**RECALL
BULLETIN:
70702**

Jamboree,
Jamboree
Sport, Tioga,
Tioga Ranger,
with serial
numbers listed
in this Bulletin

SUBJECT:
Class C Steel
Spare Wheel
and Tire
Replacement

ISSUE DATE:
October 2007

Figure 1

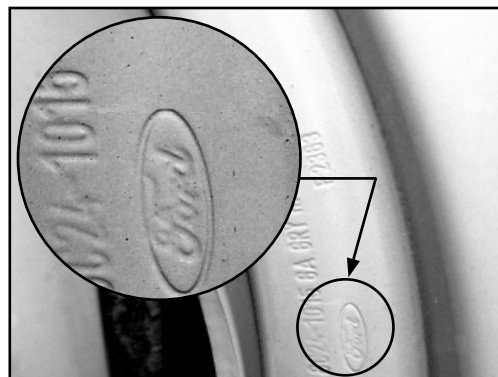
1. Locate and examine the spare wheel with tire.
 - (A) If the spare wheel has 8 hand holds, no further action is necessary.
 - (B) If the spare wheel has 4 hand holds, proceed to Step 2.
2. Look for the "FORD" logo stamped into the valve-stem side of the spare wheel, approximately 180° from the valve stem. (See Figure 1.)

Ford wheels are not affected by this Recall.

Figure 2

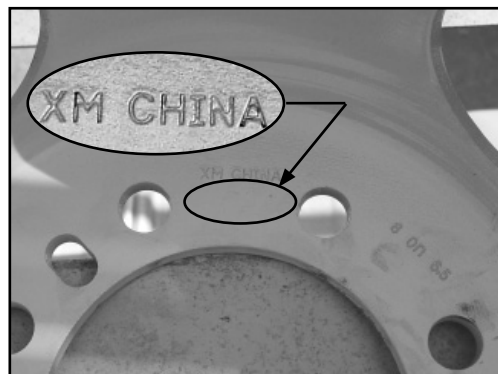
Wheels marked "CHINA" must be replaced according to this Recall.

- If the "FORD" logo is found on the spare wheel, contact Fleetwood Dealer Technical Support for authorization to inspect the additional wheels, as it is possible that the spare may have been previously mounted on an axle during a previous repair.
- If the "FORD" logo is not present on the valve-stem side of the wheel, check the opposite side for a stamping. Wheels marked either "CHINA" or "VENEZUELA" must be replaced with a new wheel and tire, part #535995 (includes wheel with mounted tire). See Figures 2 and 3.

Figure 2

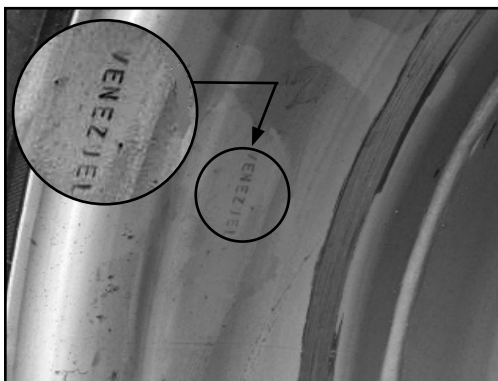
Wheels marked "VENEZUELA" must be replaced according to this Recall.
